HISTORIC AND DESIGN REVIEW COMMISSION

June 07, 2017

HDRC CASE NO: 2017-249
ADDRESS: 445 DEVINE ST
LEGAL DESCRIPTION: NCB 2957 BLK 1 LOT 12
ZONING: R-5 H
CITY COUNCIL DIST.: 1
DISTRICT: Lavaca Historic District
APPLICANT: Mauricio Namé
OWNER: Carlos Namé
TYPE OF WORK: Construction of a rear addition, exterior modifications, new 2-story rear accessory structure, hardscaping

A4.2

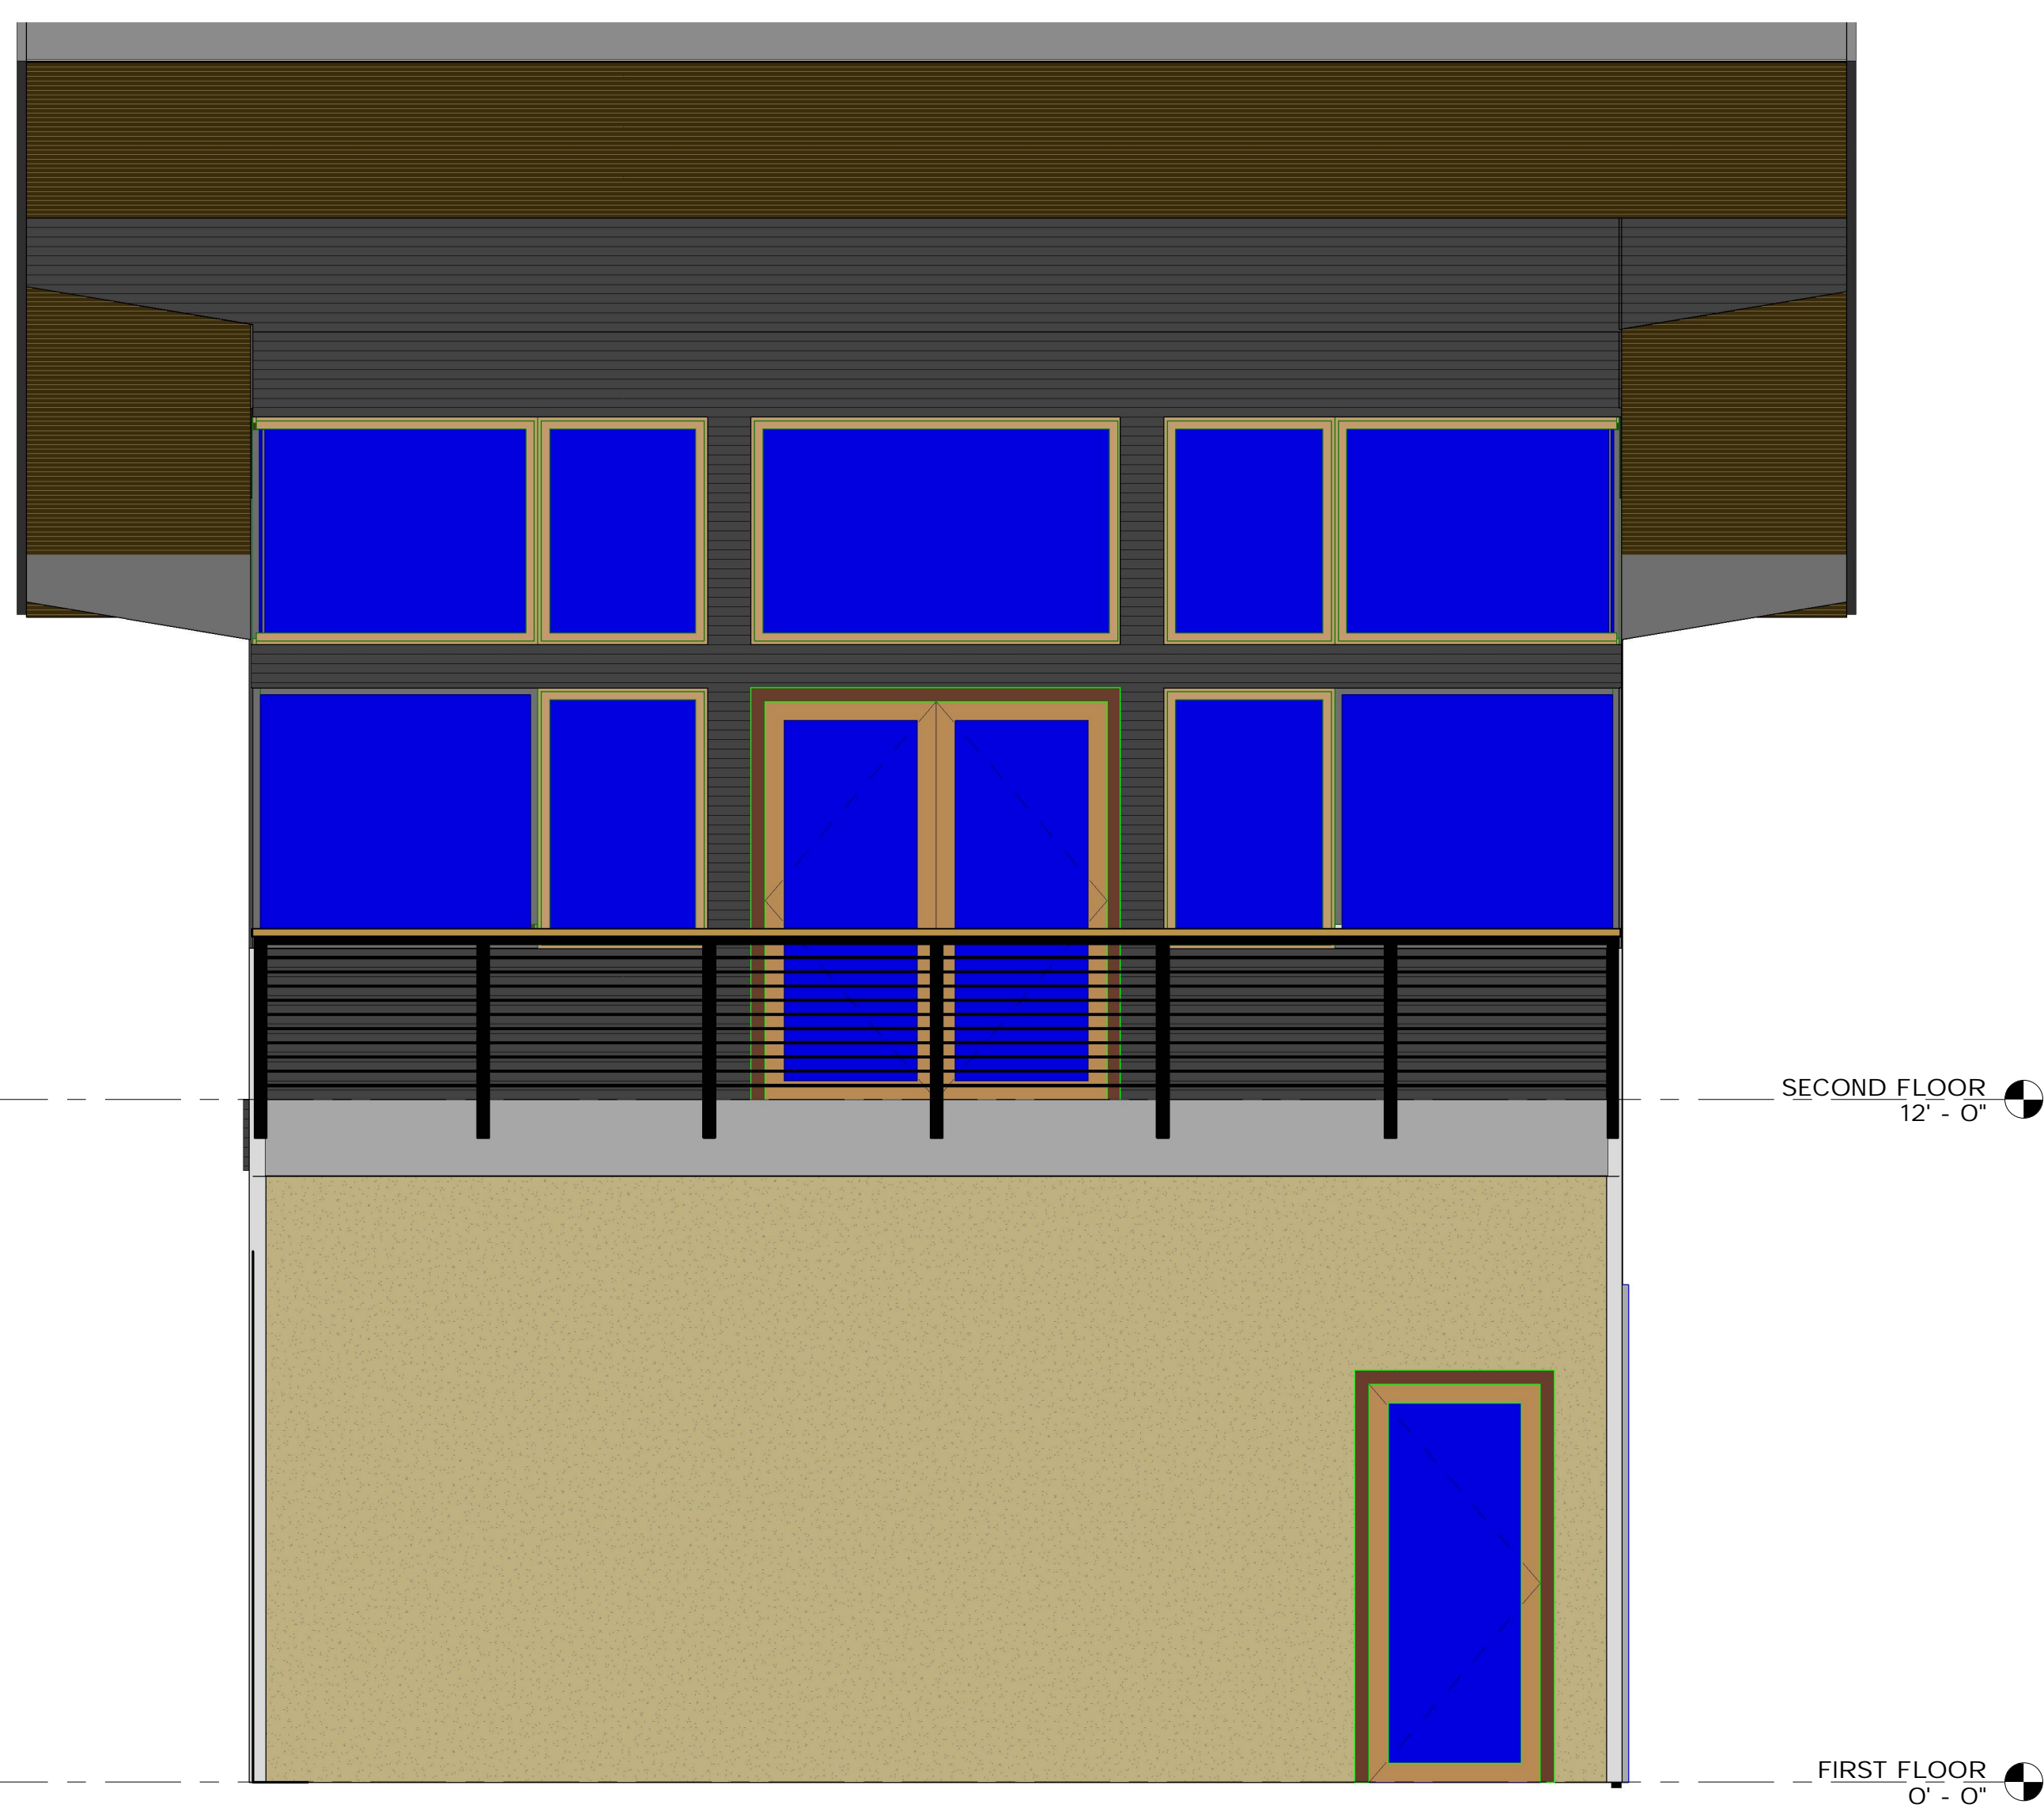
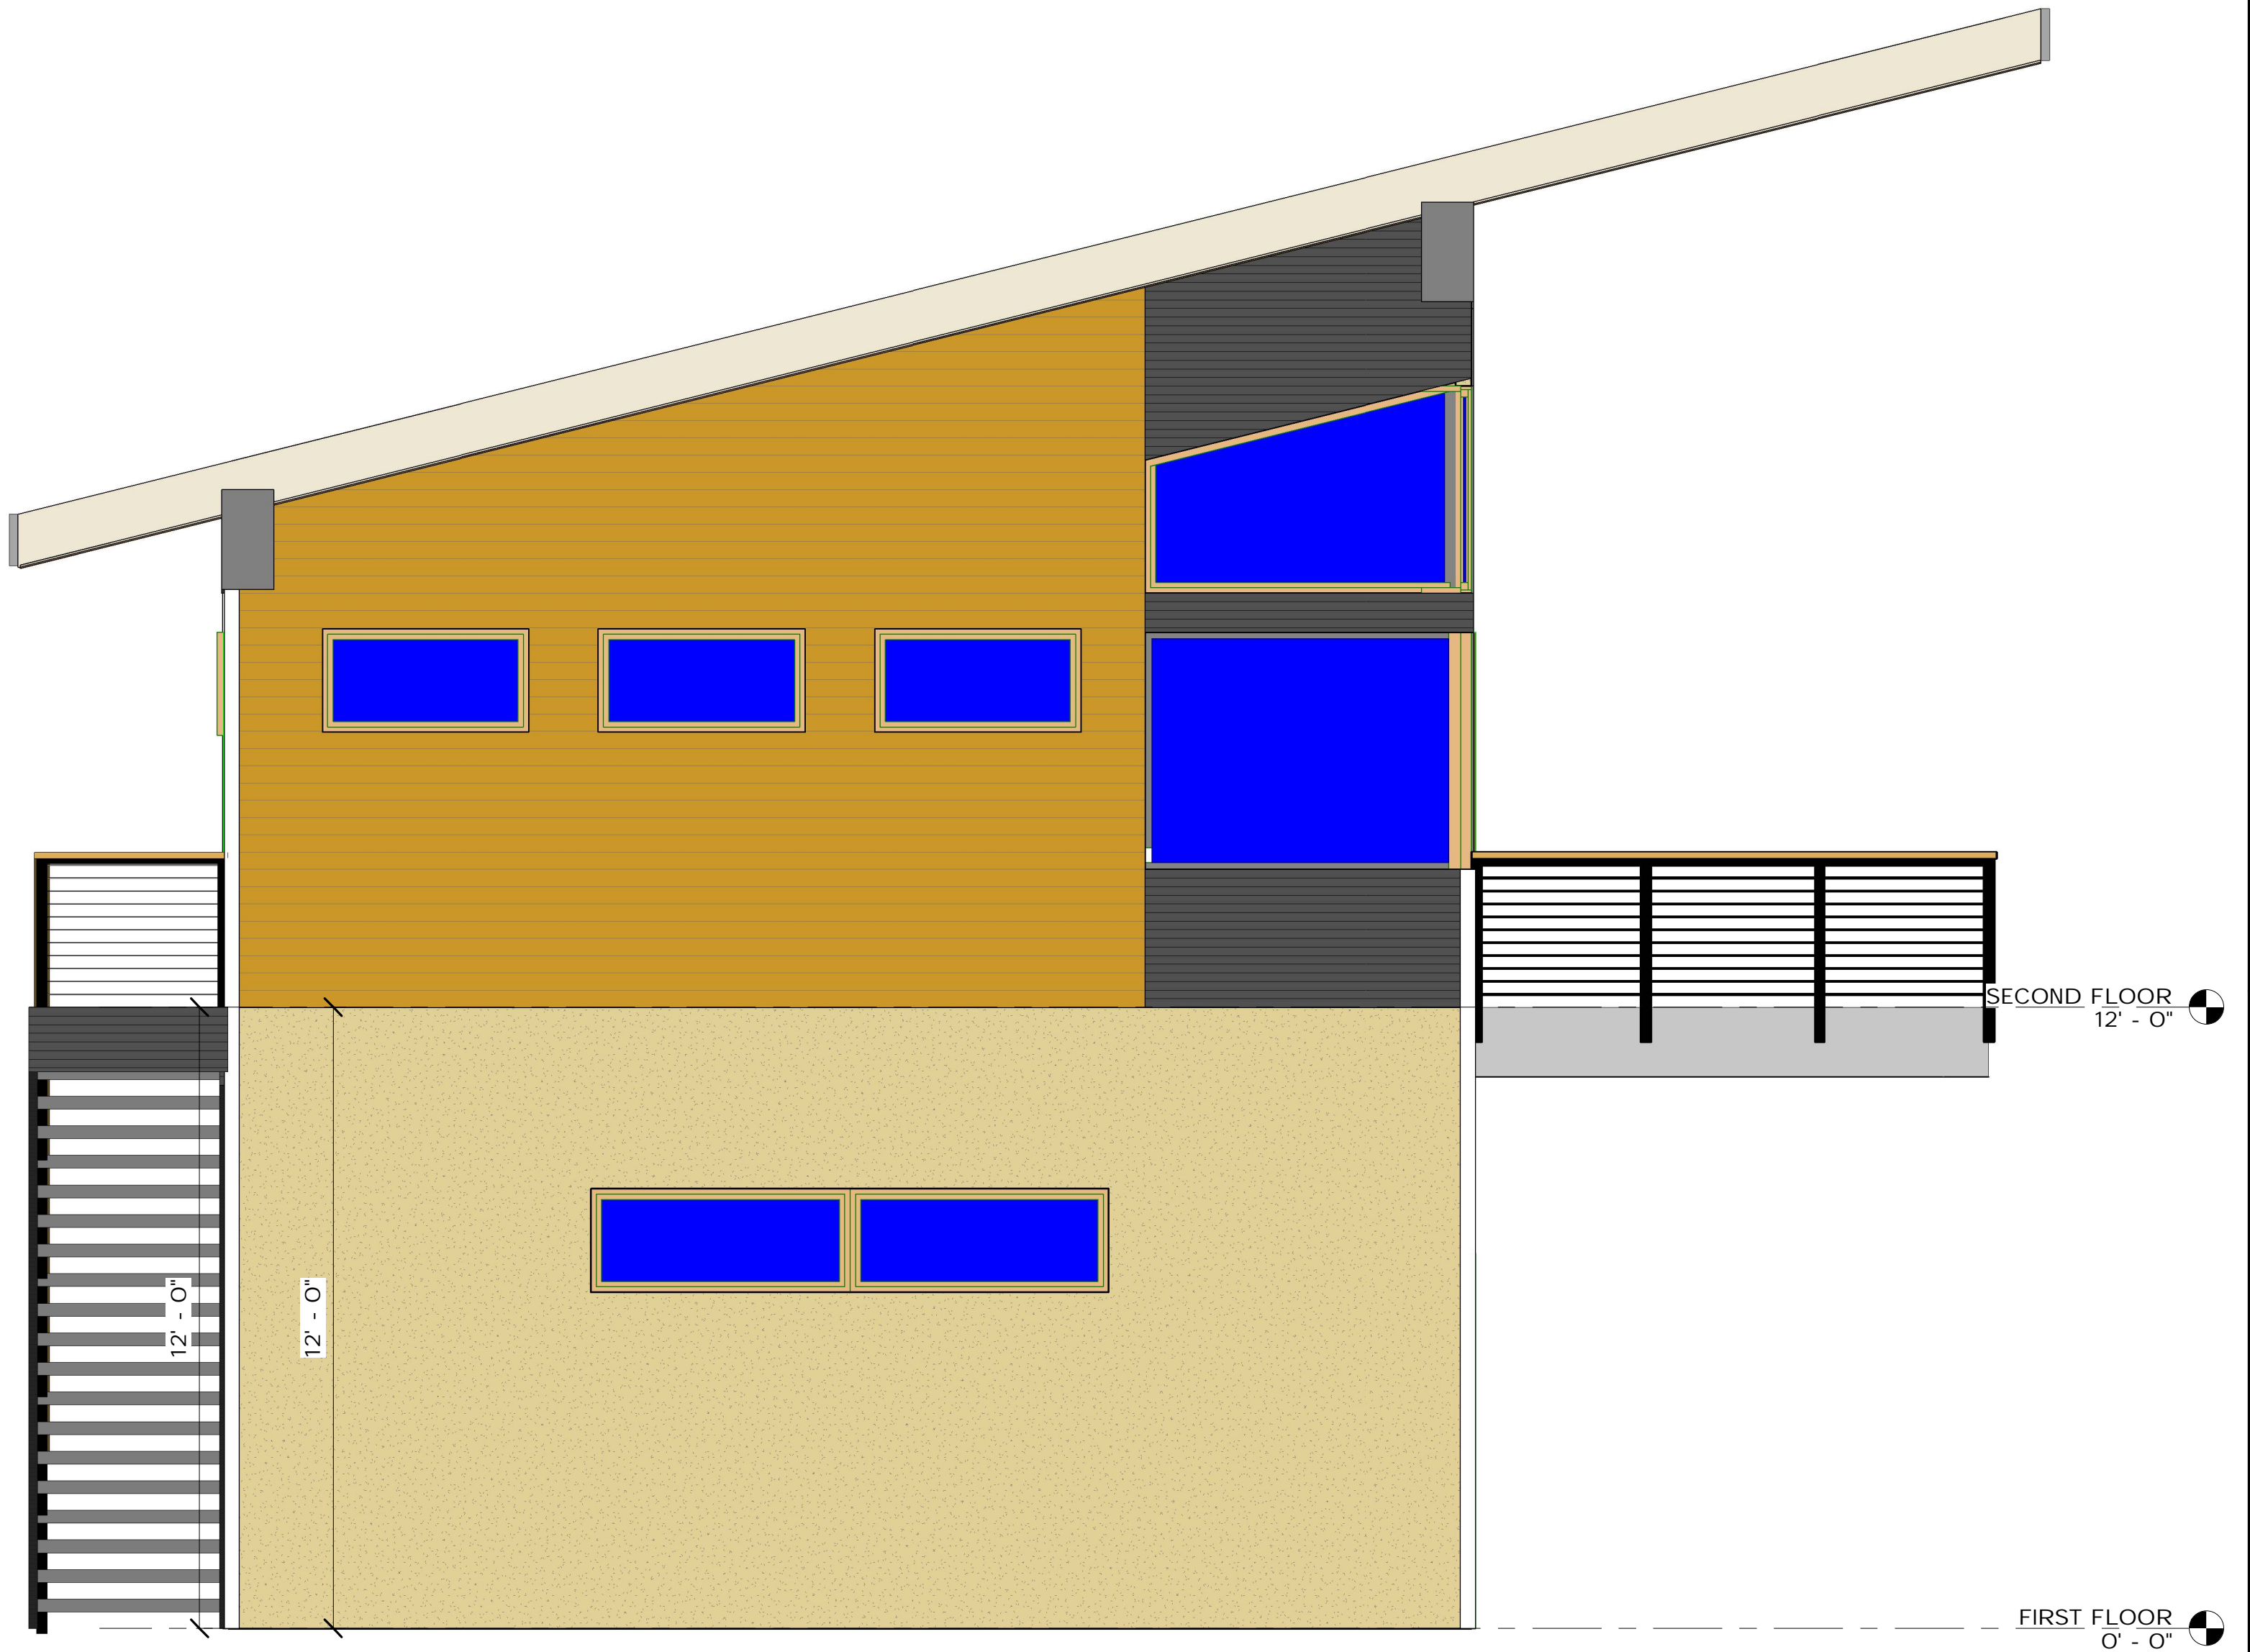
- q. **SCALE & MASS** – The applicant has proposed a two-story accessory structure with a sloped roof. According to the dimensions on the submitted elevations, the lowest point of the roof measures 21'-6" and the highest point measures 31'-3", both which are viewable from the public right-of-way. The first floor height measures 12'-0" and the second floor height measures 9'-6" up to approximately 18'-6" following the roof slope. The Historic Design Guidelines state that new construction should be consistent with the height and overall scale of nearby historic buildings. The ridge height of the primary gable of the existing historic home appears to measure approximately 20'-0" from the ground. In an elevation submitted by the applicant that indicates the height of the proposed accessory structure relative to the existing home, the new structure appears to eclipse the existing home's ridge height by over 10'-0" at its highest point. Additionally, the stairway on the side of the structure, which is viewable in full from the driveway, is almost the same height as the subordinate gable on the existing historic home. The height of the proposed structure would not only impact the view from the public right-of-way of the existing structure, but also affect the viewshed of the one and 1.5 story single family homes behind the lot

on Leigh St. Staff does not find the height of the proposed accessory structure consistent with the Guidelines or appropriate for the lot or the district.

- r. **ROOF FORM** – The applicant has proposed a two-story accessory structure with a sloped roof. The lowest point of the roof measures 21’-6” and the highest point measures 31’-3”. The roof is proposed to be standing seam metal. The guidelines stipulate that architectural details of new construction should keep with the predominant architectural style along the block face or within the district when one exists. Details should also be simple in design and should complement, but not visually compete with, the primary structure or adjacent structure. Staff finds the use of a sloping roof incompatible with the historic district, which is comprised of a high concentration of front and side gables or hipped roofs, especially within the immediate context of the lot. While similar roof styles can be found immediately adjacent to the Lavaca Historic District, there is no precedent for its use on a 2-story rear accessory structure within the district, especially in an area that is surrounded by one story single-family homes. Staff finds the proposal inconsistent with the Guidelines.

- s. **WINDOW & DOOR OPENINGS** – The applicant has proposed to install nine longitudinal rectangular fixed windows, five larger rectangular fixed windows with single muntins, and two large windows that follow the sloped roof pitch on the northeast and northwest elevations. According to the OHP Window Policy Document, windows used in new construction should maintain traditional dimensions and profiles found on the primary structure or within the historic district. Staff finds the windows inconsistent with the Guidelines.

- t. **MATERIALS: FAÇADE** – The applicant has proposed the use ICF concrete as the façade and structural material. The applicant has stated that the intention is to make the structure tornado-proof by utilizing this modern material. According to the Historic Design Guidelines for Additions, new construction should incorporate materials that complement the type, color, and texture of materials traditionally found in the district. Structures made exclusively of concrete are not characteristic of the district or surrounding context. Additionally, the elevations and renderings indicate multiple façade colors, but staff has not received material specifications that are tied to these delineations. Staff finds the proposal inconsistent with the Guidelines.

- Item 7, Staff recommends approval of the two porch railings and side staircase based on finding g and h.
- Item 8, Staff does not recommend approval of the 2-story rear accessory structure based on findings n through v. The application should address the following inconsistencies with the Guidelines if they wish to return with a new design proposal:

- i. That the applicant explores overall massing similar to historic structures and historic accessory structures in the vicinity as noted in finding p.

- ii. That the applicant reconfigures the roof form to be more consistent with the roof forms of the Lavaca Historic District as noted in finding q.
 - iii. That the applicant integrates window opening proportions that are more consistent with the Guidelines, the OHP Window Policy document, and the historic examples found in the Lavaca Historic District as noted in finding r.

- iv. That the applicant install windows that include traditional dimensions and profiles, be recessed within the window frame, feature traditional materials or appearance and feature traditional trim and sill details as noted in finding t.

- v. That the applicant incorporates architectural details and materials that are representative of the historic context of the district as noted in findings q through u.
